SERVICE BULLETINS

Manual P/N 02980501 (08/05)

Alamo Industrial

INFORMATION & SERVICE BULLETINS INTRODUCTION

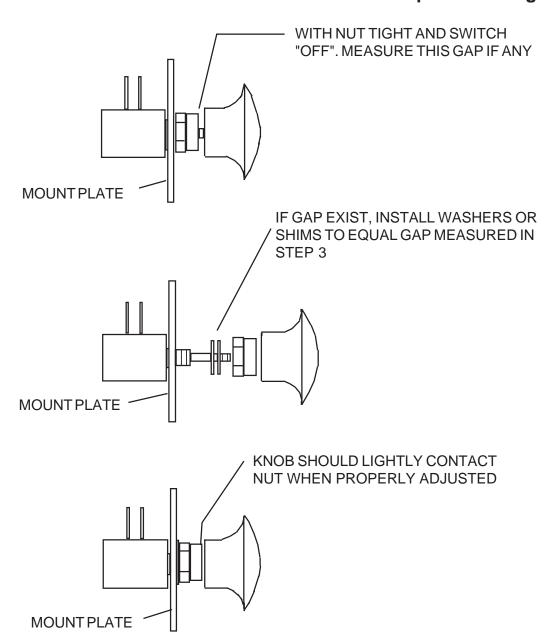
Alamo has recently received reports of failures of the referenced switch. The failures modes are:

- (a) Knob pulls off rod.
- (b) Rod and Knob pulls out of switch body.

Test performed on numerous switches indicates that the (b) failures are due to excessive force being applied to the knob when shutting off the mower. Specifically, the knobs are usually roughly slapped to turn the mower off. After internal parts of the switch are damaged, the rod can then be pulled out easily. The (a) failures are due to the knobs not being securely tightened.

To prevent these failures from occurring, or to replace a damaged switch, use the following procedure to adjust the travel of the switch. (See attached diagram).

- 3. Measure the distance (if any) between the knob and the nut. Record the measurement.
- 4. If a Gap exists between the knob and the nut, remove the knob.

- 5. Remove the nut and install the same thickness of flat washers that was measured in step 3. Install and tighten the nut> DO NOT install more washers than needed to take up the space. Flat Washer Part No. 00023500 or equivalent can be used.

Repair Procedure for Welding Cracks in Boom Heads:

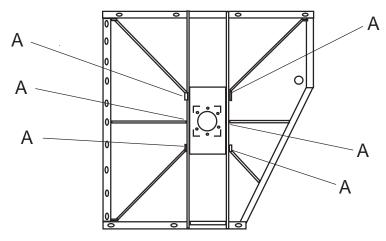
If cracks appear in the welds at points "A" as shown above, use the following procedures to repair head.

- 1. Grind a groove at the site of the crack and clean the area to be welded.
- 2. Weld the crack making a 100% weld.
- 3. After repairing the cracks, prepare the sites for installation of the gussets.
- 4. Position the reinforcing bar gusset part no. 02970111 if 90° or part no. 02970112 if 48° over the X-Bar as shown in drawing next page. Weld with a 1/4" fillet weld on the bottom and an edge weld on top. DO NOT weld the ends.
- 5. Clean and paint the area.
- 6. Reassemble any parts that were removed.

New Piston Pump used on Machete:

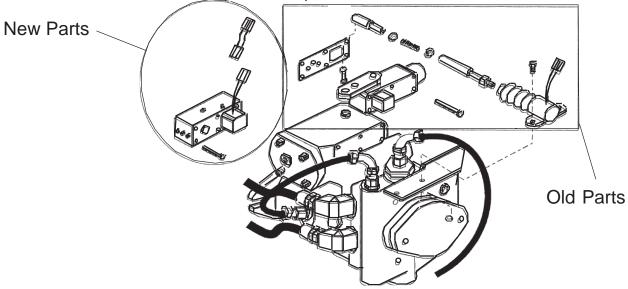
A new Pump is being used on all Machete Boom Mowers. The new pump utilizes a solenoid valve and manifold (New Parts) to control pump swashplate movement instead of the former (Old Parts) electric solenoid, Spool valve and adjustable linkage. All other parts of the pump remain the same. The new parts provide for more positive trouble free operation of the pump and do not require adjustment.

There will be a harness adapter required to connect the new two wire connector to the old three wire harness. Adapter and instructions are included in replacement parts. When the former (old part number is ordered, all the new parts will be provided.

New Seal Protector Added to Blade Bar Assembly:

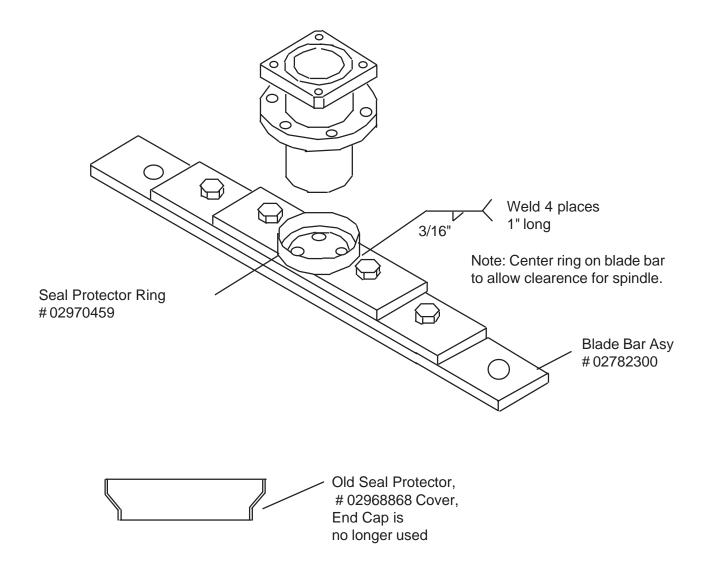
A new seal protector has been designed to aid in preventing material from wrapping around the seal cover area. While nothing can completely prevent material from getting to the seal cover, the new seal protector should greatly reduce the probability of spindle seizures due to these causes.

If a machine is operating or is going to operate in an application in which material is likely to wrap around spindle, the following parts can be ordered and installed. The old seal protector (# 02968868) which is on the spindle will be removed and discarded. The Old Part No. 02968868 will be ordered but the new Seal Protector Part No. 02970459 will be shipped with installation instructions. If only the new Seal protector is ordered the instruction sheet will not be shipped.

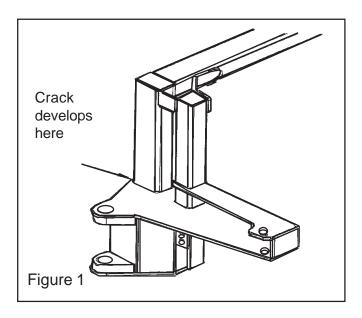
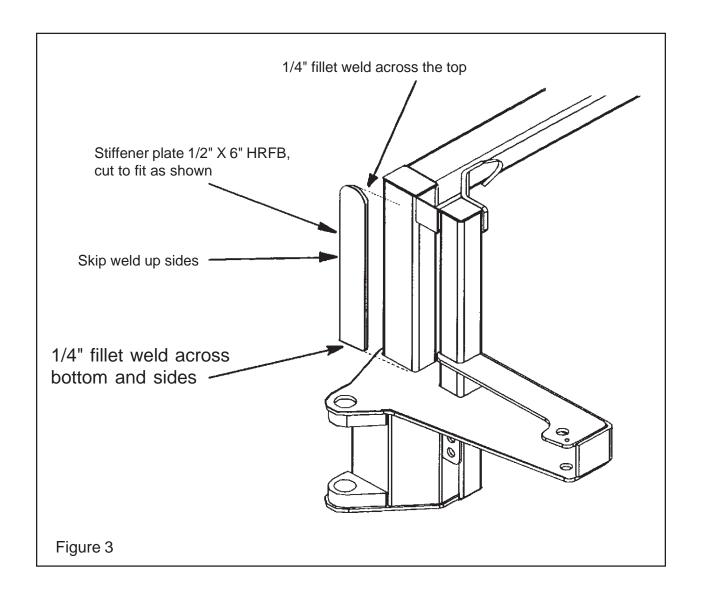
There have been some cracks in the main frame of some machete mowers

If a crack should develop (See Figure 1), use the following procedure to make repairs untill a permanent repair is developed. NOTE: This repair will aloow the machine to continue operating while a long term correction for the problem is being developed.

- 1. Grind out old weld (crack) and weld the crack, Do not use an excessive high repair weld as you will need to grind repair weld down smooth.
- 2. Prepare a piece of 1/2" X 6" HRFB cut to length (See Figure 2). The bottom should rest against the King Post frame and the top should be with in 2" of the top of the frame, this will determine the height of the repair plate (See Figure 3). Bevel the bottom side of the plate that is towards the frame to allow for the old weld. This will be evedent if you test fit the repair plate.
- 3. Place the stiffener repair plate against the vertical memeber of frame (as shown in figure 3) and tack weld into position, Make sure repair plate is flat against the frame.

- 4. Weld the plate as described in figure 3
- 5. After welding is complete, clean weld and immeadiate area. Paint the are around the repair and areound any area where the paint was damaged from making this repair.

Interference between Tube Clamps and Main Frame:

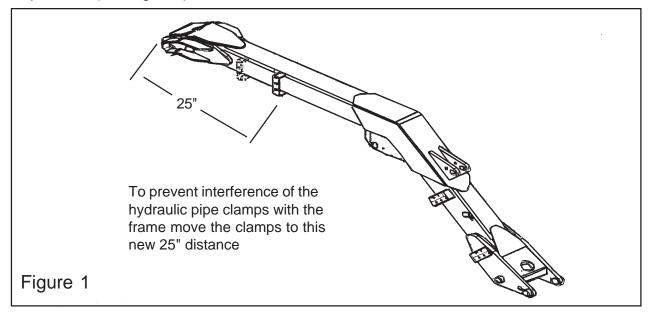
It is possible that the boom hydraulic tube clamps may contact the main frame when boom is raised to its highest position. This condition effects only machines with certain frames. If you have a machine that has this interference problem use the procedures described in this bulletin to correct the problem. (See Figure 1).

If the parts on your unit are damaged, loosen the six bolts that hold the three tubes. Cut the bracket away from the boom. Relocate the bracket on the boom so it clears the frame. Weld in place and paint. Tighten the six bolts. Total time to perform this modification will be approximately 1.5 hours time or less. If parts are required there is a kit that can be installed, the Kit # 02971938.

Valve Block O-Ring Replacement Kit available:

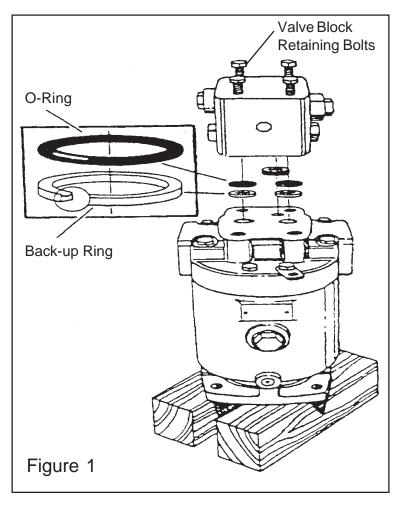
A kit (Kit # 02972094) to replace the O-Ring and Back-up Rings which are located between the valve block and the motor housing on the piston motors # 02977193 used on the Brahma rotary and Machete boom mounted cutters is available. The Valve block must be removed when the motor is replaced as it is attached to the support plate. This causes an occasional failure of the seals.

Install O-Rings and Back-up Rings on the valve block. The High Pressure Ports require an O-Ring and Back-up Ring. The O-Ring goes on first (against valve block), then the Back-up ring (against motor) as shown (See Figure 1). Install the Square-Cut Ring in the Low Pressure Drain Port of the valve block.

Tilt Link Arm Stop:

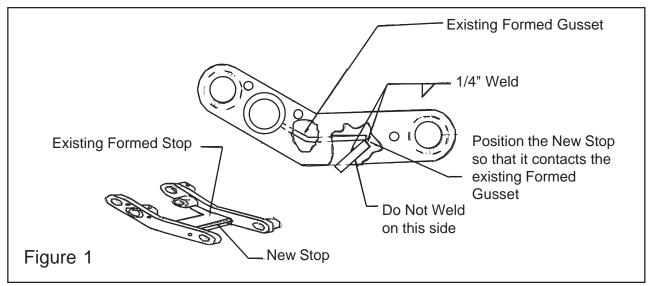
Some Machete models may exhibit interference between the head tilt cylinder and the cutter motor support plate. This can result in a bent head tilt cylinder rod, a damaged cylinder gland cap, or a damaged cutter motor housing.

A stop made from 1/2" X 2-1/4" HRFB X 6-1/2" long should be welded to head tilt link arm weldment as shown in figure 1. This will require welding and painting.

To locate the proper angle position of the new stop, carefully retract the head until the cutter motor support plate and the head tilt cylinder has a clearance of 1". Use caution, do not damage cylinder when retracting the head. Place the new stop plate in the head tilt link weldment and lay it flat on the dipper arm. Mark this position, and weld the stop in place as shown in Figure 1. It is important that the stop is installed so that it flatly contacts the dipper when retracted in order to avoid point loading on the boom. Extend and retract the cylinder to ensure proper installation.

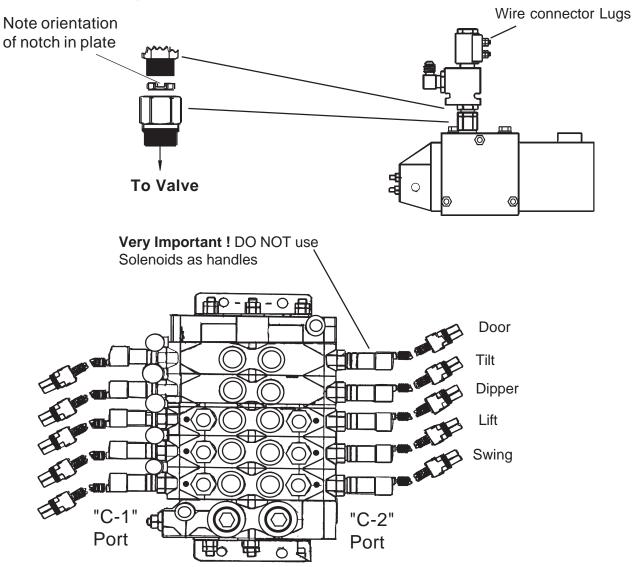
If the cutter head tilt cylinder leak down is greater than one inch of rod travel in four minutes and this is considered excessive, a lock valve may be added to the tilt function of the boom machine. Alamo Industrial has developed a cure for this and can provide (at a nominal charge) all the parts for a lock out vale for the tilt function. The Lock valve will only work on the tilt function of the Boom Machine due to the design of the hydraulic System. The only parts that must be provided by the installer are two, twelve inch pieces of 18 gauge wire. Each wire needs to have a # 8 ring connector on one end and a wire splice connector on the other end.

Identify the plus (+) lead running to the solenoid for the tilt function. This solenoid is located across the valve from the fitting you installed. Remove approximately 2 " of the outer plastic covering from the wires coming from the solenoid. Splice one of the 18 gauge wires you provided into one of the wires. Connect the other end of that wire to a lug on the solenoid. It makes a difference which wire runs to which connector. Insulate any exposed wires with electrical tape.

- 1. Remove the tilt section hose from the "C-1" Port
- Assemble the parts as shown above.
- 3. Attach the hose to the fitting on Lock valve, Test and run.

Figure 1

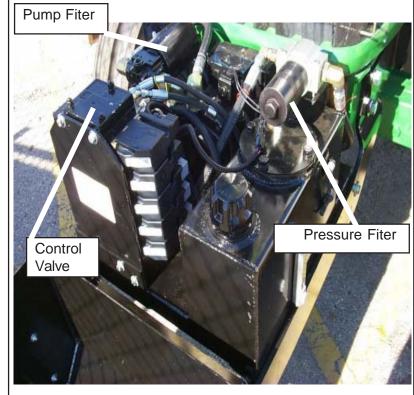
The 2001 Machete will reflect a change in the way some of the components are mounted to the tractor. New Machete units received from the factory, or assembled by dealer after S/N MB21-01572 & UP or MB24-01245 & Up will have the control valve in a new location. It will no longer be mounted on the frame. The Control Valve will be located under the front pump cover in the front of the tractor. This change was made to better protect the Valve and its components from debris and

As you can see in figure 1, the valve is fastened to a plate that is mounted to the units hydraulic tank. The Pressure Filter was relocated to a bracket on top of the tank. Both the Pressure Filter and the Pump Filter are accessible and can be changed with minimal effort. Sepaarate hose exstension were used to extend the hose reach to the front of the tractor. If a hose connection is not easily accessible, then the valve and mounting plate can be unfastened an arranged to allow for romm when servicing.

These Changes were made to better protect the valve and its components. These changes will only be seen on the new units after Jan. 2001 and is not intended for units already in use.

Buzz Bar Drive Coupling Design change:

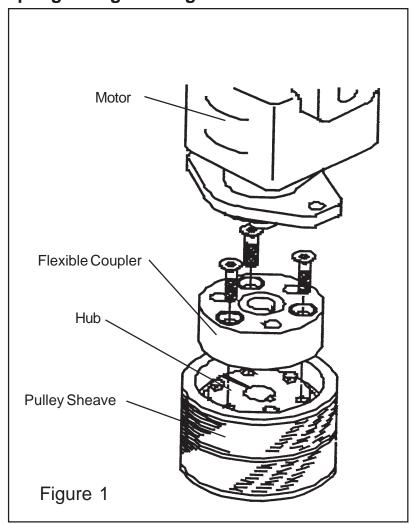
There has been a design change to the drive coupler assembly for the Buzz bar Cutting Head. If a flexible coupler, Alamo Industrial P/N 02974245 (for Machete) or P/ N 02974246 (for A-Boom & Slopemower), are ordered they will be a different design. The new flexible coupler design will be molded rubber with metal inserts. The new molded rubber version will directly replace the machined design using the same part number. An installation drawing, that describes the assembly in detail, will be shipped if a new coupler is ordered. this bulletin is to inform you of the design change (see Figure 1) If there are further questions please contact Alamo Industrial's Technical Service Department. Also See Manual Insert Sheet P/N 02978337.

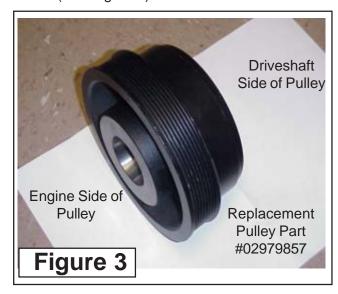
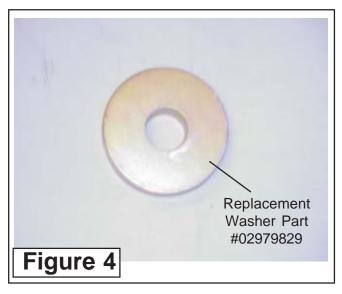
In an effort to comply with certain requirements in regard to Tier II Emission Standards, Deere and Company initiated a change to the crank shaft pulley on many of the new 6020 series tractors. This was a random change, which did not affect all tractors. In addition, a specific serial number break does not exist to identify the affected units.

<u>The Tier II pulley</u> can be identified as a 5 spoke design as indicated in the figure above (See Figure 1). This pulley must be changed to the tapered lock, solid cast pulley as shown to allow adaptation of the required front pump drive system used to power the Alamo Industrial products. (See Figure 2) To change the pulley:

Remove the original pulley retaining bolt, shouldered washer and pulley. (See Figure 1) Clean nose of Crankshaft using LOCKTITE® number 7649 clean and cure primer. Place a light layer 2 mm to 3 mm (.079 - .118 in.) of LOCKTITE® brand adhesive number 680 (TY15969) to the leading edge of the crankshaft nose.

Install the replacement pulley (P/N 02979857) If any paint inside of pulley it needs to be removed. Make certain to align the pulley with crankshaft, install pulley. (See Pulley Figure 3). Do not hammer on Vibration Damper (Pulley) it must be handled in a way that avoids impact damage. Make certain that you installed the Locktite primer and adhesive as described in previous step before you installed the pulley, this is very important.

<u>Install the new retaining washer</u> (PN 02979829) so that it fits flat against the pulley. The original factory washer will not be used. (See Figure 4) Use the original Factory Pulley retaining Bolt (See Figure 1).

Install the original factory retaining bolt and torque to John Deere Specifications 500 N-m (369 ft. lbs). Check John Deere Service instructions for to asure proper Torque of Crankshaft Pulley Retaining Bolt has not changed. (See Figure 1 for original Bolt) . Pulley retaing bolt must be dipped in clean SAE30 oil before installing bolt.

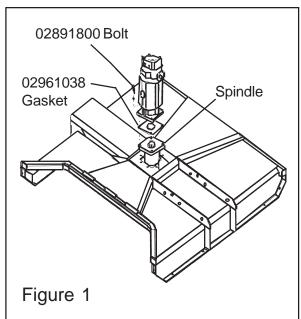
Replace motor to spindle bolts with longer bolts. Original Bolts may not keep Motor tight to spindle.

1. Clean the head, especially the area around the Motor and Spindle connection. Remove the four bolts which attach the motor to the spindle. Lift the motor off the spindle and place it to the side.

- 6. Remove the rag, and check to be sure that the spindle is properly lubed.
- 7. Apply a coating of silicone gasket material to the motor and spindle housing flanges.
- 8. Apply a small drop of Locktite to each of the four new bolts.
- 9. Install the motor and the four new bolts and tighten them to the proper torque (120 ft. lbs.).

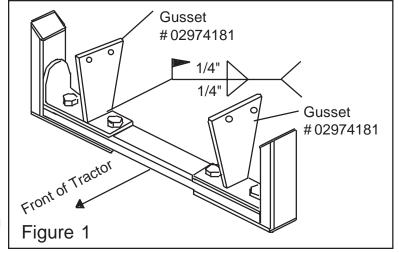
Support gussets have been added to the lower crossmember frame support

- 3. Utilize a continuous 1/4" weld to attach the bottom of the gusset to the lower crossmember between the two crossmember bolts on each side of the tractor as illustrated in figure 1 and in the assembly drawing provided with the kit. Weld both sides of gusset.

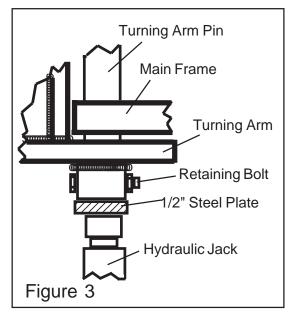
- 2. This will require drilling to install a larger Retaining Bolt and welding to install the Snap Ring grooved boss (See Figure 1) on the bottom of the Turning Arm Pin, The Old retaining Bolt at the bottom of the Pin is a 3/8", this will be removed and the hole will need to be drilled out to a 1/2" to accept the new larger bolt.

- 4. Support Boom with a hoist as shown in the operators manual and/or service manual before beginning work on retaining pin.
- 5. From the under side use a 1/2" thick steel plate and a hydraulic Jack up under turning arm pin to prevent the pin from falling out when the retaining bolt is removed. Remove the 3/8" retaining bolt and drill the hole out to a 1/2" hole so you can install the 1/2" Retaining Bolt (See Figure 3)

- 6. With the new 1/2" retaining bolt installed (do not remove or lower Jack without retaining Bolt installed) lower the supporting hydraulic Jack and 1/2" steel plate but do not remove it. (See Figure 3).

- 7. Install the new Grooved Snap Ring Boss up under the existing Boss that is welded to the turning arm. Making certain that the OD of new boss is aligned with the OD of the old one, if it is not aligned the ID of the boss's will not be aligned and Pin cannot pass through it. Using the 1/2" steel plate and the hydraulic jack, raise jack till there is enough pressure on new boss to hold it straight and aligned with the existing one. Do Not apply so much pressure that you distort the new boss. (See Figure 4)
